# SITE PLAN REVIEW AND APPEARANCE BOARD

### ---STAFF REPORT---

ITEM: **Lisa Building (2016-209)** - Class V Site Plan Modification, Landscape Plan and Architectural Elevations to demolish an existing building and construct a new one-story retail building with 7,249 sq. ft. with a waiver request to reduce the landscape terminal island in the parking area from nine feet to one foot.

Proposed Color Elevations 34-1618C

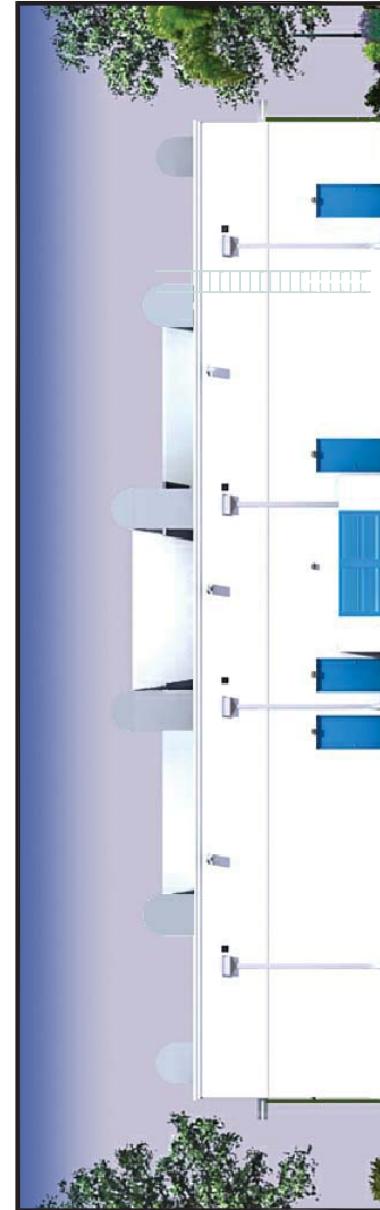
The proposed building has been designed with an Art Deco style of architecture, which is identified as one of seven permitted architectural styles. The execution of the style leans toward the streamline modern period of Art Deco. The design includes Art Deco characteristics, such as windows at the corners, cantilevered eyebrow for shade, horizontal streamlined details on vertical elements and neon details. Concern was voiced during the review process regarding the exaggerated quality of the columns and roof line so the elevations were updated to refine the design.

Pursuant to LDR Section 4.6.18(B)(14)(ii)(3) Treatment of Blank Walls, architectural design elements must be proposed to reduce blank wall space in the Downtown Area. The architect has included additional treatments to the blank wall space on the south and north elevations, despite the zero lot line condition. The treatment includes a cable trellis system to establish a green wall over time.
